**Re: 2AM-DOH0713 – Interim Water Management Plan**

## Interim Water Management Plan – Comment Responses

### **Sedimentation Pond, Pollution Control Pond and Temporary Holding Pond Drawings and Storage Curves**

Doris North Camp		
		Screenshots of Sed, Pollution and Temp Pond As-Built Models		
		Date: July 25, 2011	Approved: JBK	Figure: 1
Job No: 1CH008.033 File: Sed&PollPond+PadDTempPondLiner_AB_20110725	HOPE BAY MINING INC

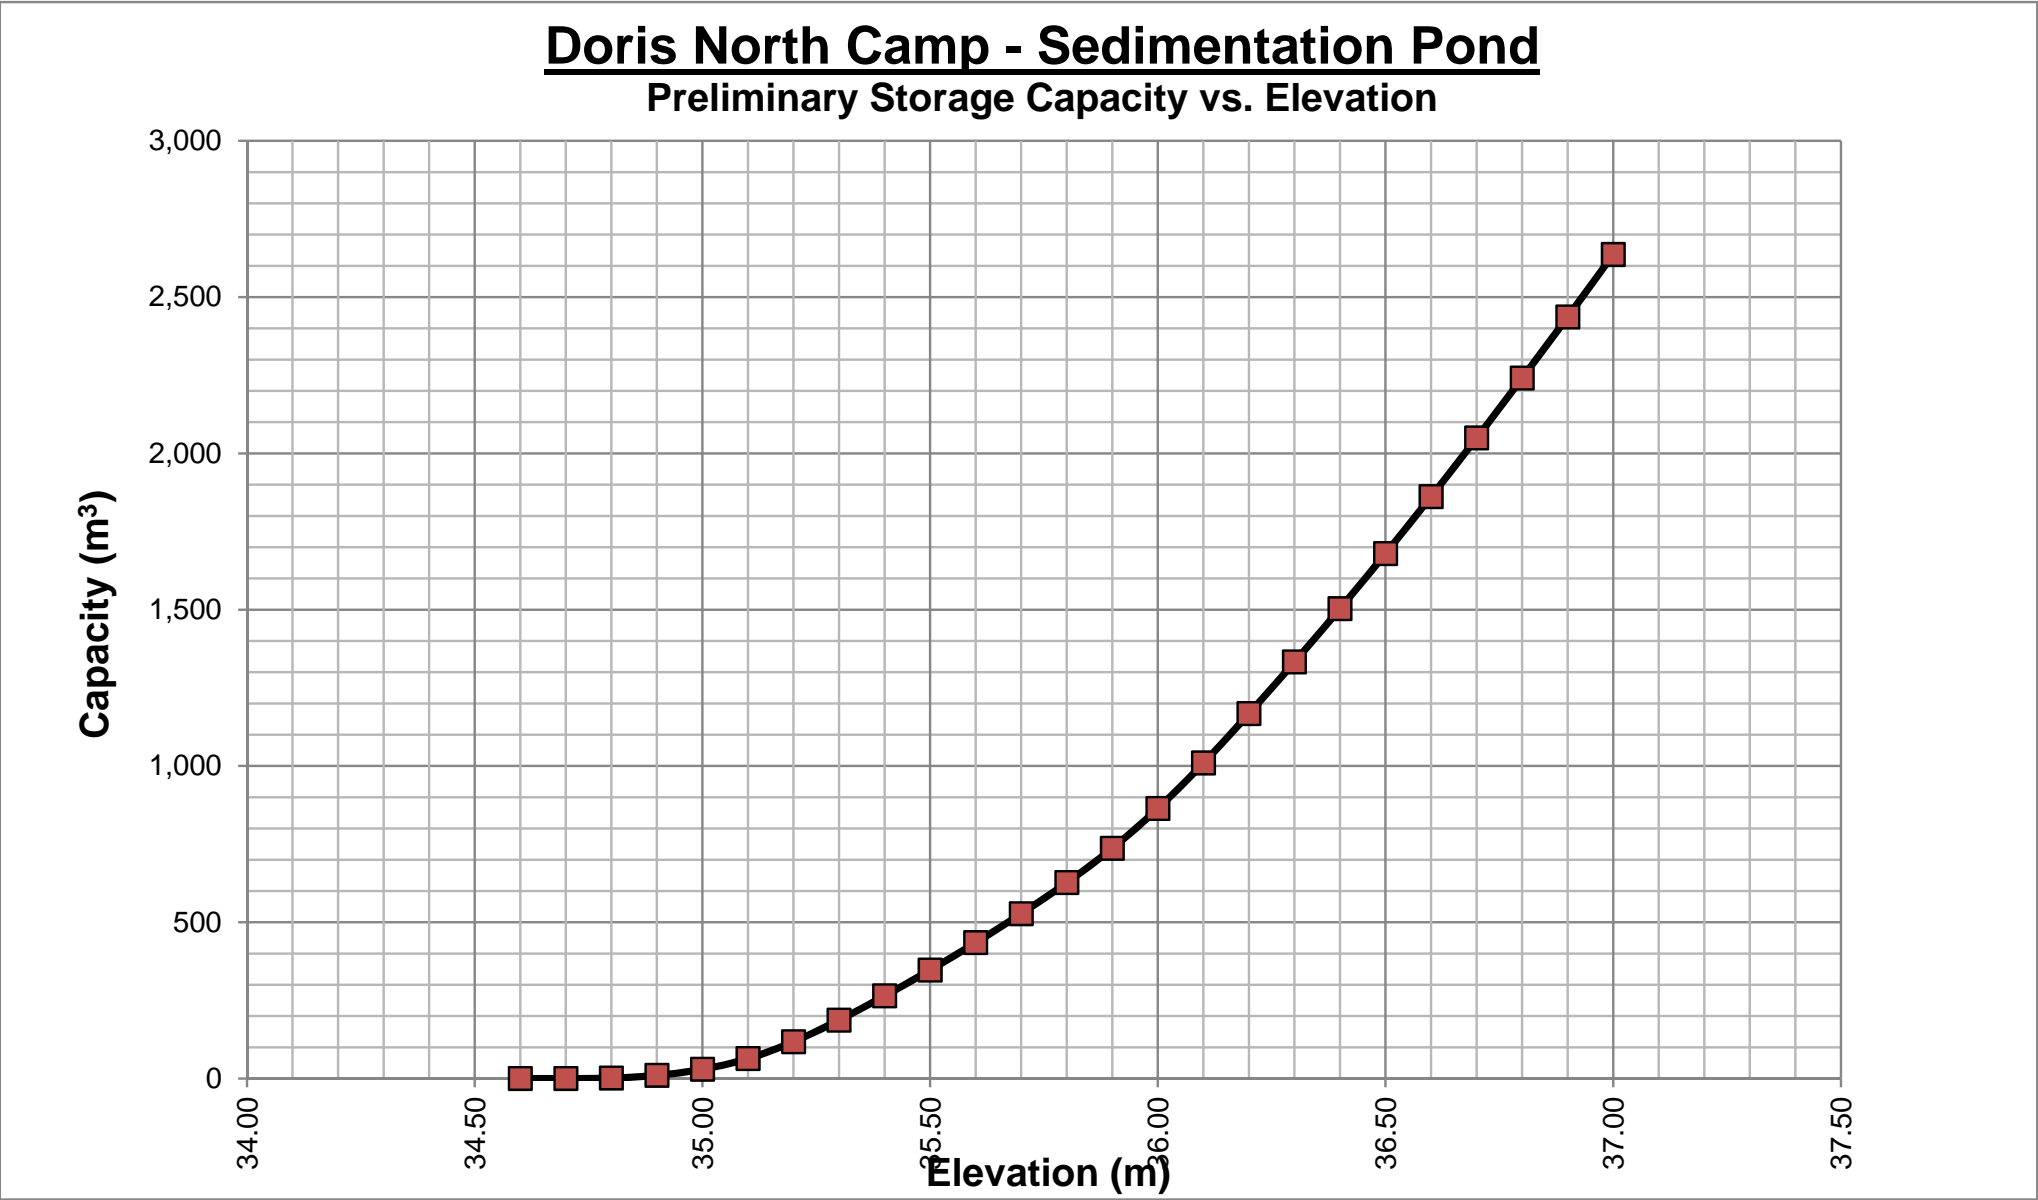
DATE	ORG./ NAME	ID#	COMMENT/ISSUE	HOPE BAY MINING LIMITED RESPONSE
24 March 2011	KIA/ Luigi Torretti	1.	HBML should standardize the terms used to define areas. Terms are sometimes used interchangeably, and sometimes not defined properly defined, causing confusion.	We have standardized the terms used to describe the basins and sub-basins from which the runoff originates.
24 March 2011	KIA/ Luigi Torretti	2.	HBML should clarify the design life of the facility, and whether the facilities would or could expand to meet future development needs.	The purpose of the plan is to describe how the facilities will be operated during this interim period before impacted water can be discharged to Tails Lake.
24 March 2011	KIA/ Luigi Torretti	3.	<p>As-built or IFC details of the facilities are needed, including:</p> <ul style="list-style-type: none"> <li>a. pump sizes, capacity and backup plans, as well as discharge protocol;</li> <li>b. clarification of where the diversion pumps divert water to, and how the water is collected;</li> <li>c. confirmation that construction materials are geochemically benign and free from blasting residues;</li> <li>d. liner details (the pads, Pollution Control Pond and the Sedimentation Pond should be lined with an impervious liner in order to direct flow and store potentially contaminated water);</li> </ul> <p>confirmation of design capacity for the current pond size, and that capacity can be increased as and when needed.</p>	<p>Issued for construction drawings of the Sedimentation and Pollution Control Ponds are attached.</p> <ul style="list-style-type: none"> <li>a. Pumps for the pump stations are portable units and mobilized as needed. The largest pump is a Godwin 4” HL4M pump and the smallest is a 2” trash pump. Attached are the specs on the Godwin pump. Pumping from Pollution Control Pond to Temporary Holding Pond Protocol is as follows: <i>“Once the Pollution Control Pond has accumulated a volume equivalent to 24 hours of pumping capacity or approximately 240 m<sup>3</sup> the accumulated water will be pumped via a pipeline to a Temporary Holding Pond.”</i></li> <li>b. The diversion pumps pump water to the diversion outfall above the sedimentation berm for the Overburden Stockpile. The diverted water is collected in collection areas adjacent to the pumps.</li> <li>c. The materials used in the construction of the plan are characterized in the following report: SRK, 2007. Geochemical Characterization of Quarry Materials, Doris North Project, Hope Bay, Nunavut, Canada. Prepared for Miramar Hope Bay Limited.</li> <li>d. The Pollution Control and Sedimentation Ponds are partially lined. Details are shown in Attachment 1 to these comments.</li> <li>e. Attachment 1 shows the Sedimentation and Pollution Control Ponds and their stage-storage curves.</li> </ul>

NEWMONT  
The Gold CompanyHOPE BAY MINING LTD.  
DORIS PROCESS AREAPOLLUTION CONTROL POND  
FRESHET WATER TREATMENT PLANT  
ISS R.O. P&ID

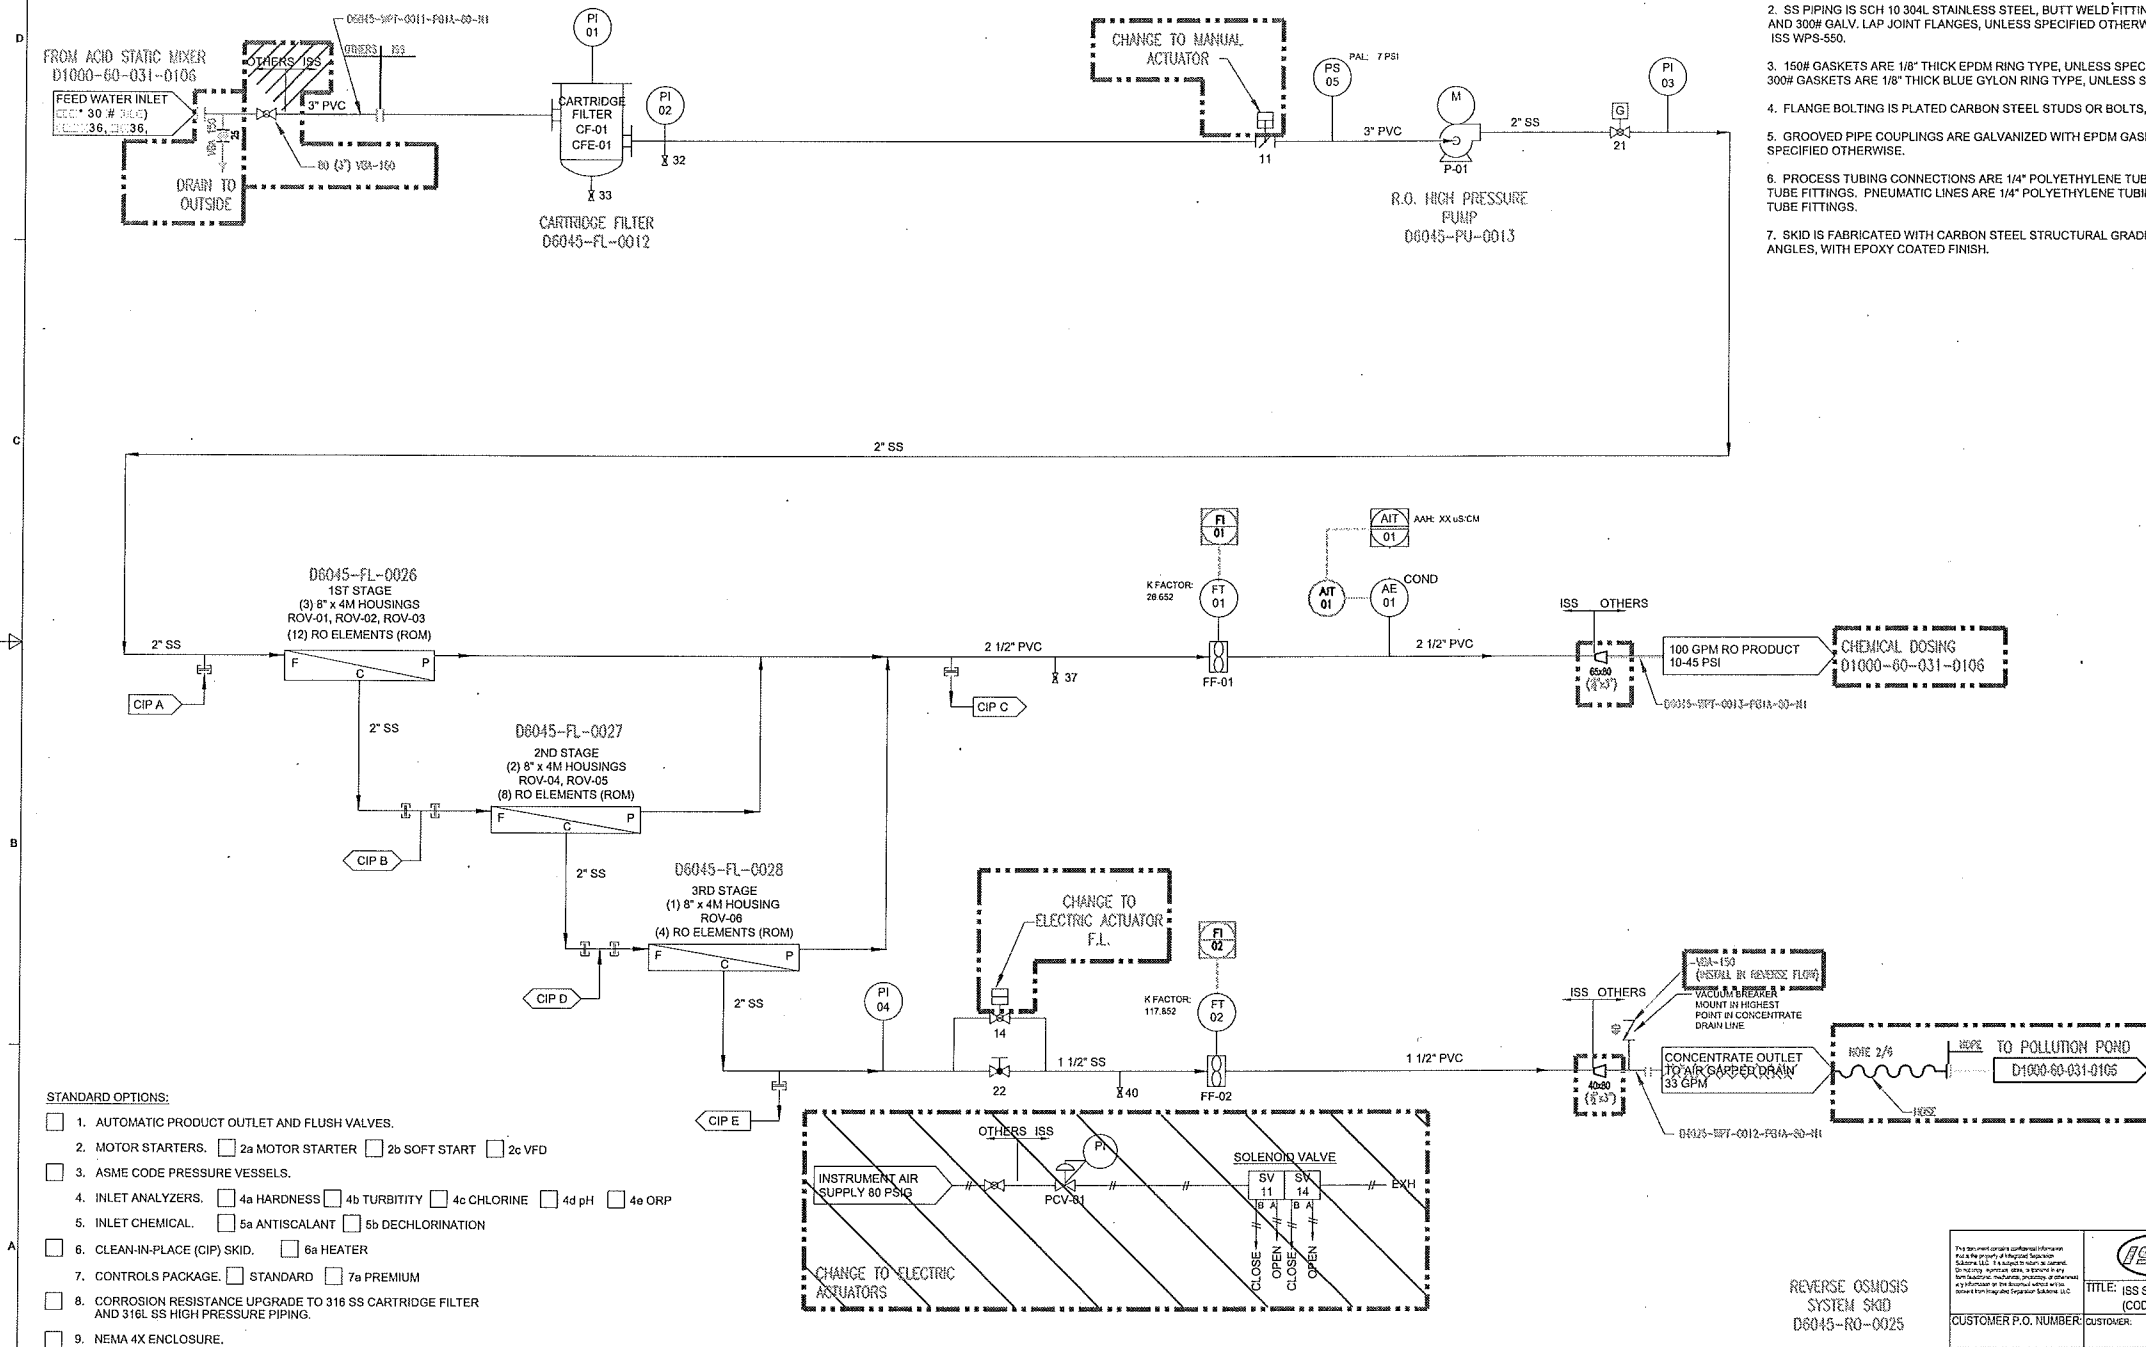
24 March 2011	KIA/ Luigi Torretti	6.	The Plan figures suggest that Pad R reports to the Sedimentation Pond. Is this correct, or does it report to the Pollution Control Pond?	Pad R reports to the Sedimentation Pond.
24 March 2011	KIA/ Luigi Torretti	7.	Details are needed regarding the Reverse Osmosis (RO) Plant: a. HBML should confirm that the RO plant will be built and ready to use prior to the need to treat contaminated/non-compliant water;  b. Waste stream flows need to be detailed;  c. How will HBML manage contaminated/non-compliant water that requires further treatment?  d. IFC designs are needed. A geotechnical engineer should supervise construction, and an independent geotechnical engineer should inspect the facility annually.	a. Commissioning of the RO plant began on 12 July 2011. b. The RO plant treated/treats impacted water collected by the Pollution Control Pond and stored in the Temporary Holding Pond. c. In accordance with the Plan, water that does not meet discharge objectives will not be discharged. Water that does not meet quality objectives can be retained within the Temporary Holding Pond which has sufficient holding capacity for the design storm runoff volume from the Mine Area. d. Comment acknowledged. Specifications for the RO plant are Attachment 2 to this response to comments.

23 March 2011	INAC/J. Rogers	13.	<p>4. Referenced Draft 2009 Golder Report</p> <p>In my review I noted that the December 2009 Golder report titled, “Doris Project Area 2008 Hydrology Baseline Update,” referenced in the submitted plan is a draft version. This report should be finalized taking into account the comments provided in Item No. 3 (above) and HBML should ensure that accurate climate data are used in the design of their project’s Sedimentation and Pollution Control Ponds. Also, whenever possible, future HBML submissions should not reference draft reports/ plans.</p>	Comment acknowledged.
23 March 2011	INAC/J. Rogers	14.	<p>5. Reverse Osmosis Water Treatment Facility (RO Plant) HBML should describe the conditions that would necessitate the installation of a RO Plant, such as a specified volume of effluent within the Pollution Control Pond and/or maximum freeboard level. The plan should also include general design specifications of the RO Plant such as treatment capacity, membrane type, filtration size, plant specific operations and the time required to commission a facility.</p>	The reverse osmosis plant was commissioned starting on 12 July 2011 to proactively manage impacted water. The capacity of the RO plant is 20 m <sup>3</sup> /hr. Other specifications of the RO plant are Attachment 2 to these comments.
